METRO CENTRE

A Review of the Transportation Elements

Prepared by the staffs of:

April 1971

Fig. 4

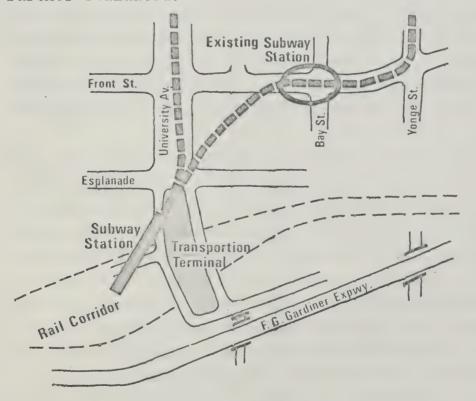
A fourth alignment, (Figure 4) considered originally, is not evaluated in this report. This alternative involved discontinuation of the subway loop and termination of the Yonge and University lines at a new station under the new railway station (Transportation Terminal). The existing Union Subway Station would be retained as a station on the Yonge line. The alignment has been eliminated for the following reasons:

• Since the Transportation Terminal has been moved east (coinciding with the realignment of University Avenue) it is no longer possible for the proposed terminal subway station to lie within the confines of the Terminal itself. The track (and therefore the station) would be west of University Avenue due to the curvature restraints as the track turns south from Union Station.

- This alternative splits the Yonge-University loop system into two separate lines which is considered to be unacceptable from the standpoint of transit operations.
- Due to the expected distribution of peak hour passenger loads it would still be necessary to rebuild and expand the Union Subway Station.
- Other disadvantages would be the construction problems (similar to those encountered on University Avenue for the subway loop extension) and the high costs anticipated.

This alternative is therefore unacceptable and is not further evaluated.

SUBWAY EXTENSION TO QUEENS QUAY Fig. 5

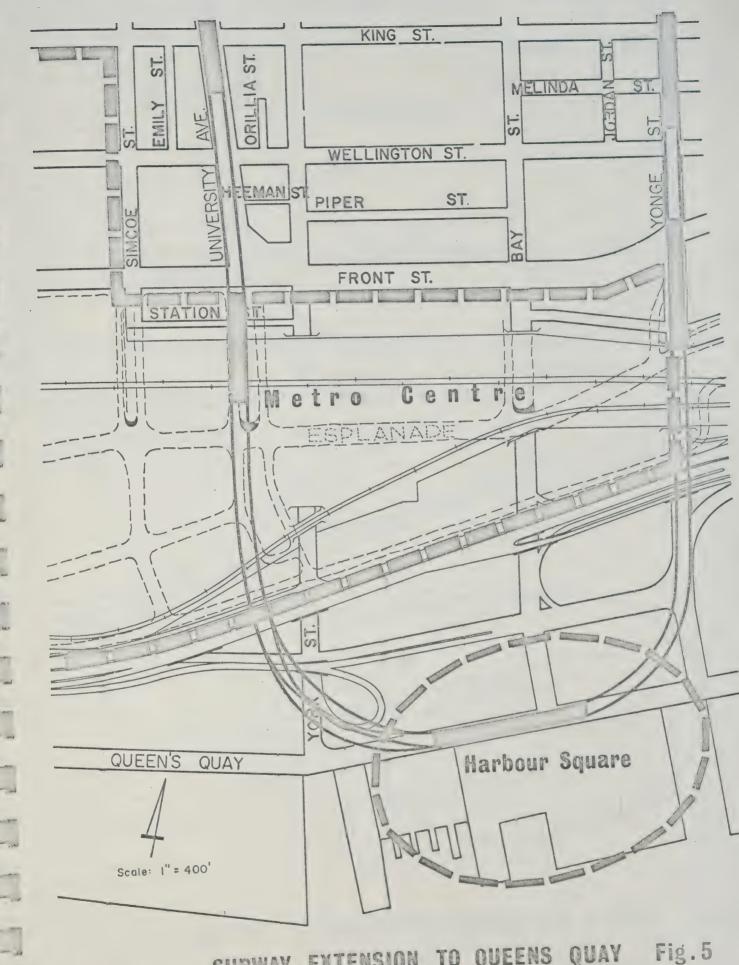
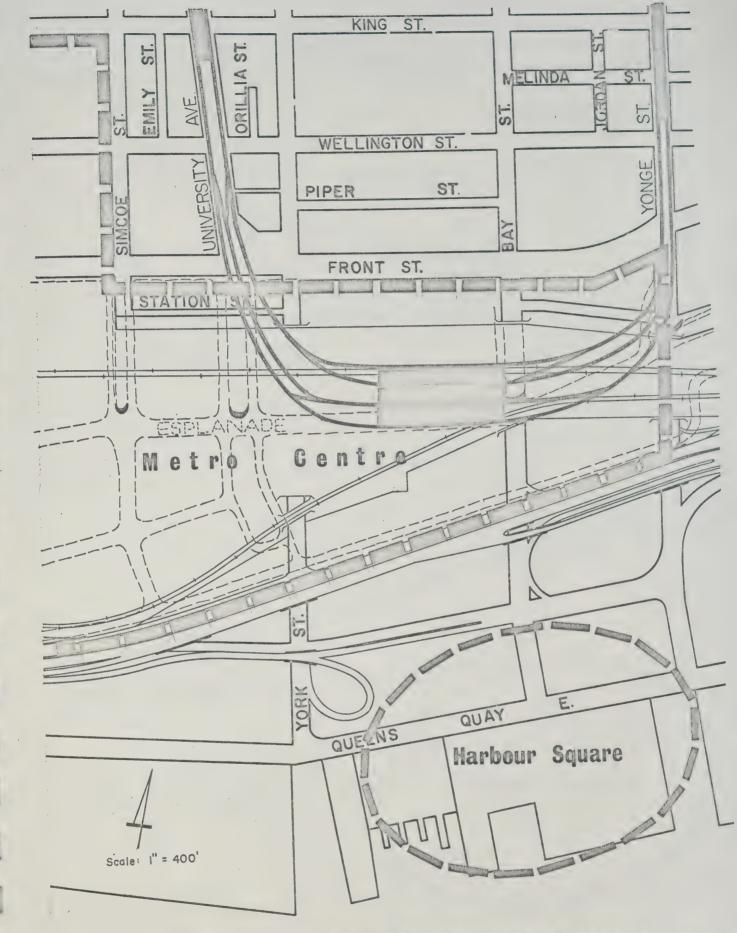
In this alternative the Yonge-University Subway loop is extended to the south with north-south stations on the University alignment at the Transportation Terminal and on the Yonge alignment in the vicinity of Esplanade. This alternative would also have a third station at the bottom end of the loop in the vicinity of Queen's Quay and Bay Street (Figure 5)

Because of the significant extension and the additional stations on the line, the "around-the-horn" movement to King, Queen and Dundas would be materially affected.

The third station at the bottom end of loop would require extensive trackage facilities to provide for "through" operation as well as "turnback".

The increased line distance for this alternative is estimated at over 3500 feet with an increased riding time of 2 minutes, 6 seconds. To maintain the existing headways an extra train in each direction would be required.

See also pages 20-22. Complications at the Yonge railway underpass would be greater than for the Esplanade scheme. Complete re-construction of the underpass would be required for this alternative.

While this alternative provides two additional stations to serve Metro Centre, the two subway stations (at the Transportation Terminal and at Yonge Street) do not provide nearly as good service to the main commercial super block as the station at Bay in either the Front Street or the Esplanade alternative.

SUBWAY EXTENSION TO ESPLANADE STREET Fig. 6

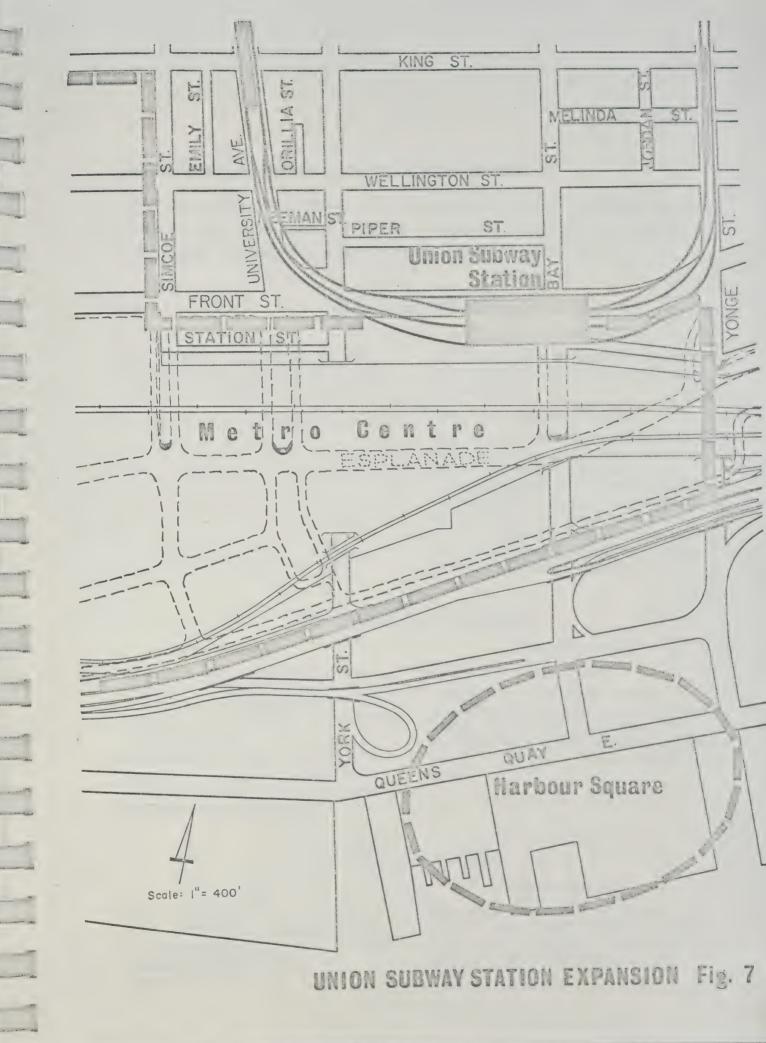
This alternative involves also abandoning the existing Union Station and creating a similar expanded station facility to the south in the vicinity of Esplanade (Figure 6).

Difficult to construct without serious disruption to subway operation.

While the "around-the-horn" and turn-back operations could still be provided, the additional travel time in this alternative would be greater than that at the expanded Union Station but not as great as that caused by the extension to Queen's Quay.

Increased trackage under Federal Building at Front and Yonge (this building is not scheduled to be demolished but is to be added to the development.
